DOCUMENT 00 91 01

ADDENDUM NO. 1

ANDREW P. HILL

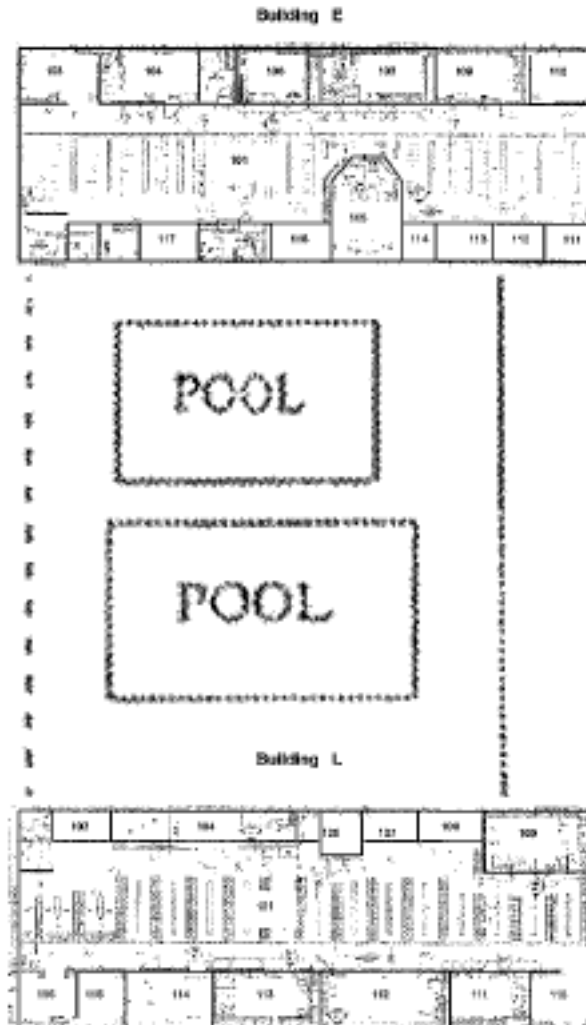
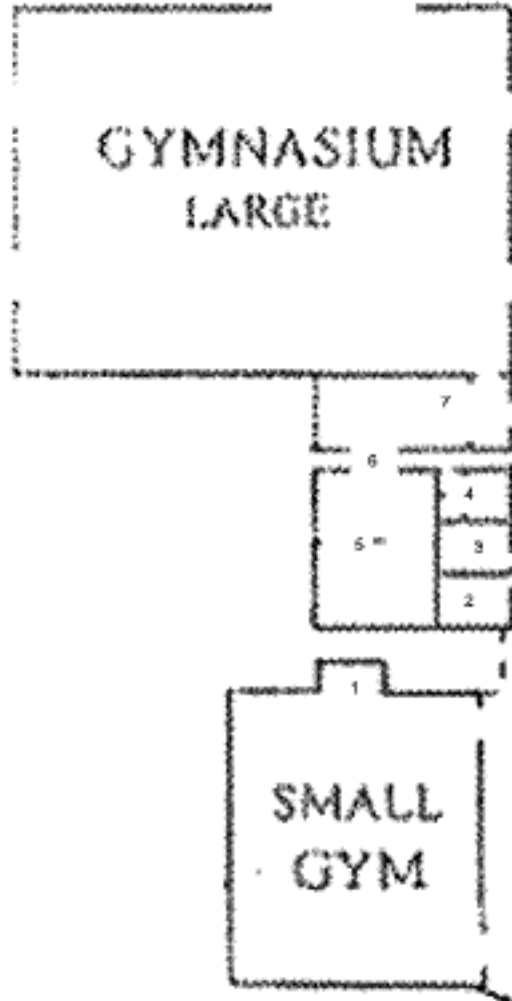
1. Original Scope of Work only for Building D, L, and P
Change: Delete Scope for Building D
Add: Building E – Boys’ Locker Room and Building F – Large Gym
Add: Report for Building F-Large Gym, Site Plan and Aerial Map for Andrew Hill HS.

2. Change in Scope of Work. Add details scope of work per Building
 - a) Building E – Boys’ Locker Room
Inspect roof, check for leaking and repair if necessary. Clean, and power wash existing roofing. Repair and replace roof blister, fill large ponding areas to have slope and water flows down to gutters. Clean and clear gutter/drainage on both sides to make sure there is no clog. Address metal edge and reseal ductwork seams. Clean and prep existing roof for re-coating approx. 5,000 SF of roof with Silicone Roof Restoration System.

- b) Building L – Girls’ Locker Room
Inspect roof, check for leaking and repair roof if necessary. Clean and clear gutter/drainage to make sure there is no clog. Clean and power wash existing roof. Then prep existing roof for re-coat approx. 5,000 SF of roof with Silicone Roof Restoration System.

- c) Building P – Small Gym
Inspect roof, check for leaking and repair if necessary. Replace and provide new caulking of wall flashing. Fill large ponding areas. Install flashing grade sealant on fractures at curb corners, pipe penetration and scuppers. Enhance crickets. Clean and prep existing roof for re-coat approx. 4,535 SF of roof with Silicone Roof Restoration System.

- d) Building F – Large Gym
Inspect roof, check for leaking and repair roof if necessary. Repair or patch exposed membranes. Reseal/recoat HVAC Duct and the post base of the ductwork. Reseal, paint with rustproof capsheet flashing around the roof. Address and fill large ponding areas. Raise height or enhance the crickets to have slope for water flows to scuppers.
